To: Design Review Board
From: Aoife Blake, Associate Planner
Date: March 10, 2022
File No.: DRV22-00064
Subject: **SWYFT APARTMENTS
CONCEPTUAL DESIGN CONFERENCE**

SWYFT APARTMENTS

DESIGN RESPONSE CONFERENCE

SWYFT MASSING PROPOSAL

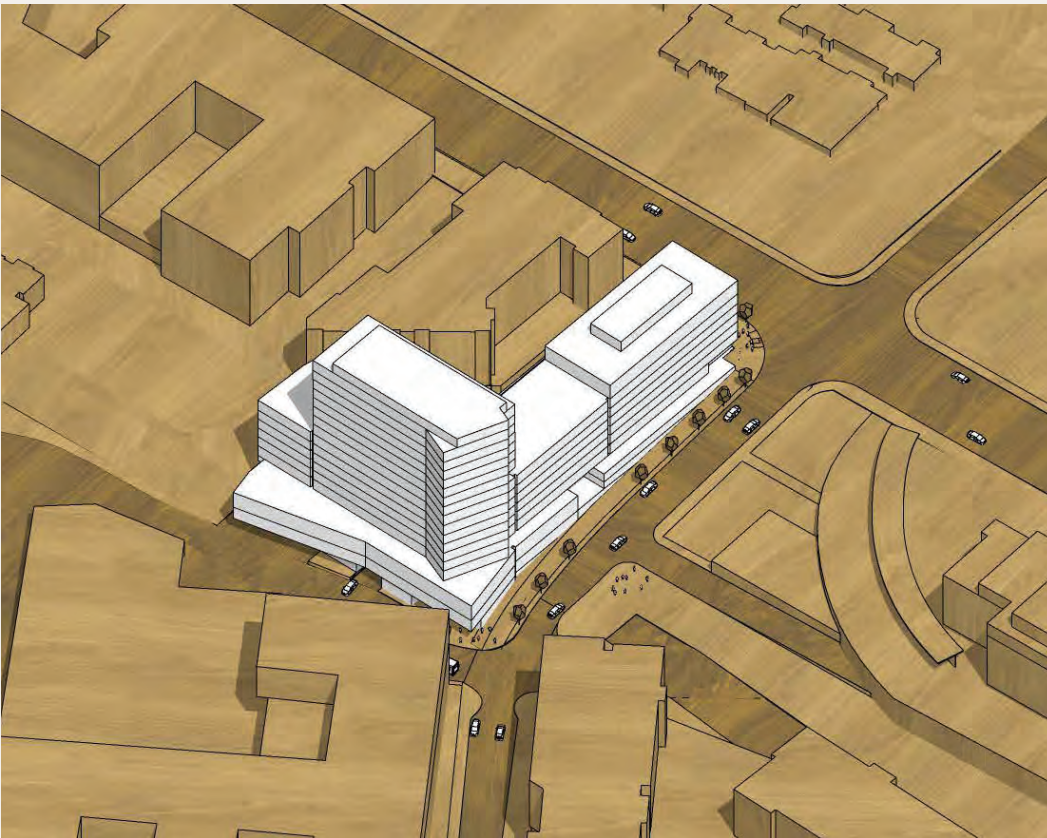
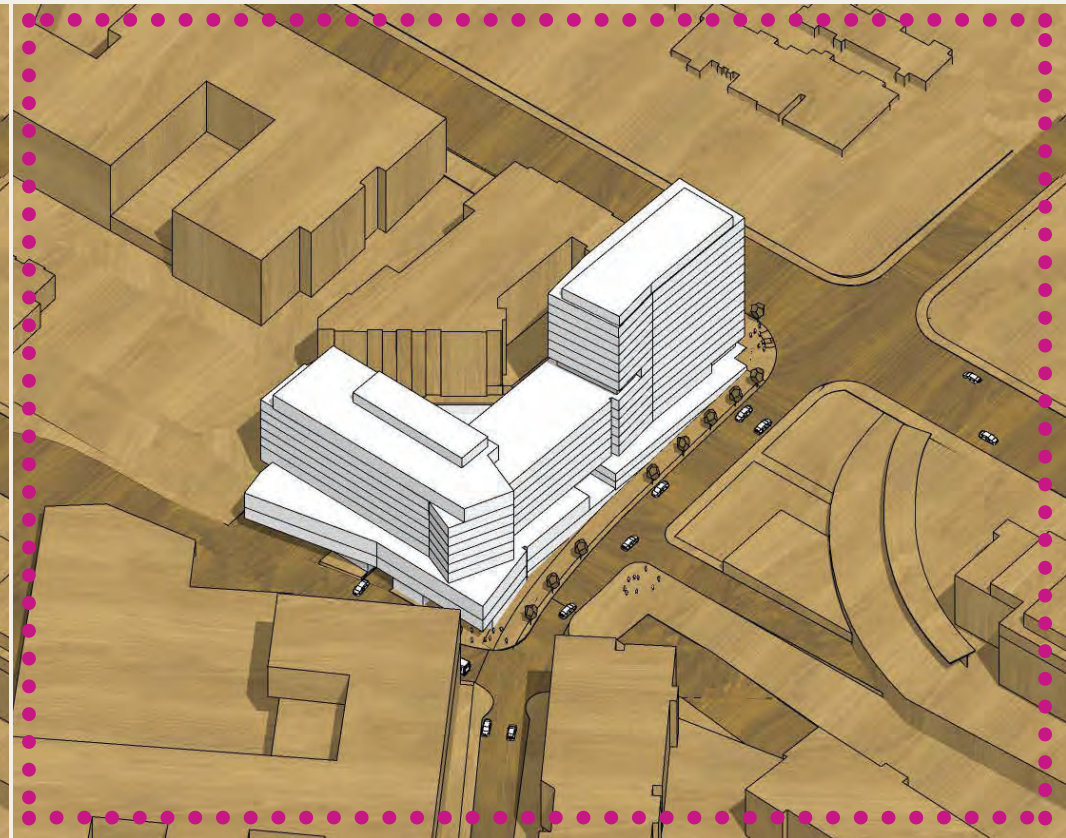
In order to make a determination, the Board wants to understand the differences between schemes 2 & 3 and to get a better sense for height differences, solar impacts and pedestrian experiences.

- 01 Zoning analysis of surroundings properties (*block diagrams*).
Build up massing on surrounding properties for proposed massing schemes 2 & 3.
Show existing condition with allowable development per current zoning.
- 02 Building sections with respect to surrounding streets and buildings. Include ABE and height information.
- 03 Solar study.
- 04 Street sections (*include views at the pedestrian level*).
 - South end of the site
 - Traveling East on NE 128th Street
 - At each pedestrian entrance
 - Garage entrance (*south façade*)
 - Open space
 - View from the NW corner of the site (*adjacent to the Jade building*) looking SW into the site and the open space
